ADDENDUM NO. 1

APRIL 16, 2024

AVON, MASSACHUSETTS
AVON SELECT BOARD

CENTRAL STREET AND PAGE STREET TANK REHABILITATION

2.6 CABLE SLEEVE

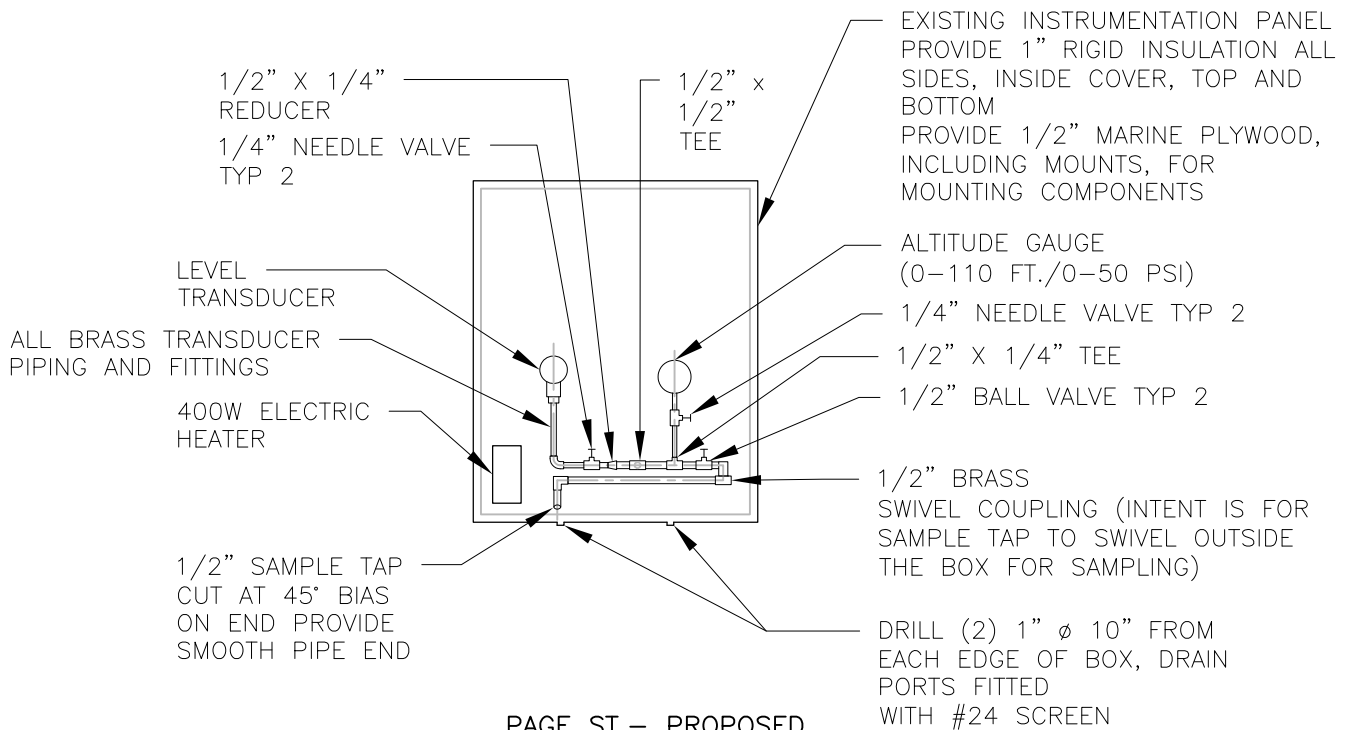
09300A Part 2 Miscellaneous Work – Page Street

Insert:

- A. Provide one (1) cable sleeve that shall be 3M DBI-SALA, manufacturer number 6160054 or approved equal.
- B. Cable sleeve shall be stainless steel, 3/8 inch in diameter, have a minimum 310 pound capacity, and include a carabiner.
- C. The cable sleeve shall be manufactured by the same manufacturer as the safety climb system and shall match cable diameter.

DWG: ADDENDUM 1-FIG. 3

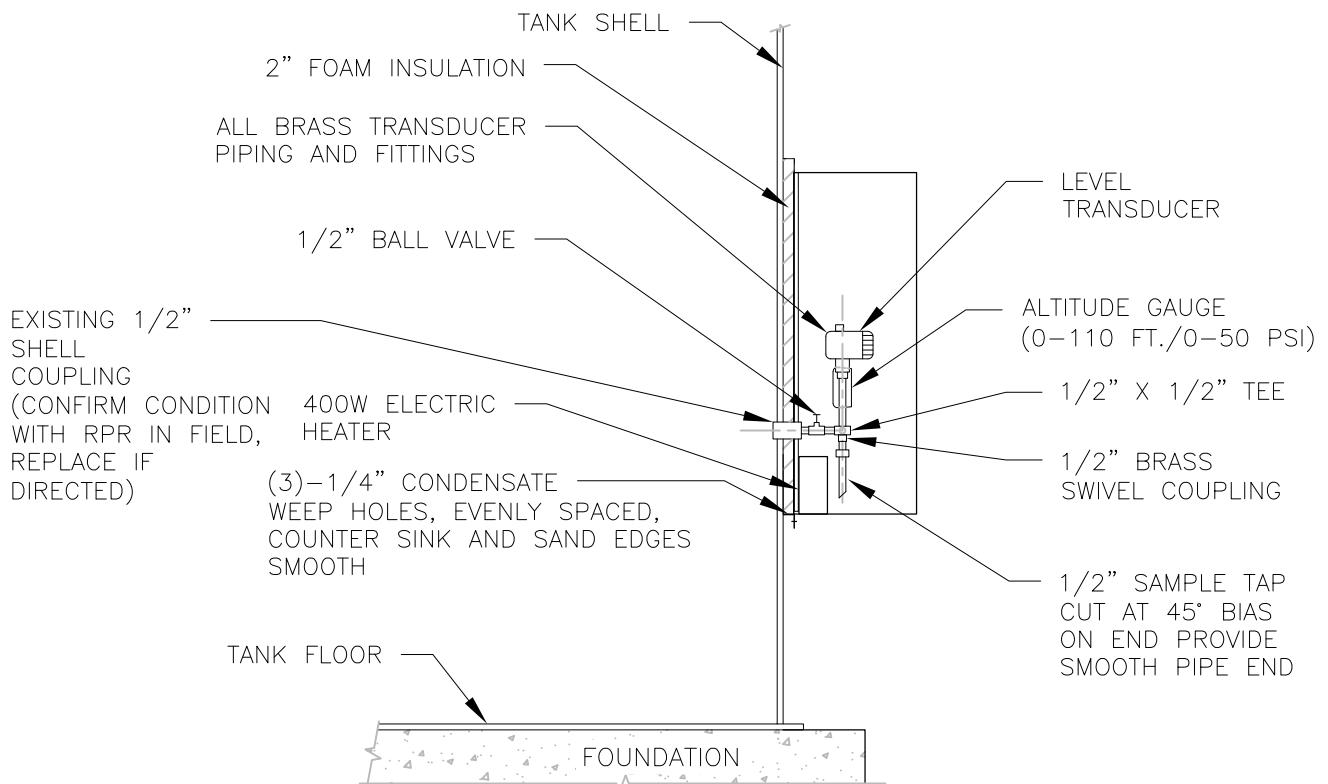
- DWG 3 – revised instrumentation panel piping configuration
- Measurement and Payment Page 17
- Central and Page St Photo Logs

PAGE ST.- PROPOSED INSTRUMENTATION PANEL FRONT VIEW

PAGE ST.- PROPOSED INSTRUMENTATION PANEL SIDE VIEW
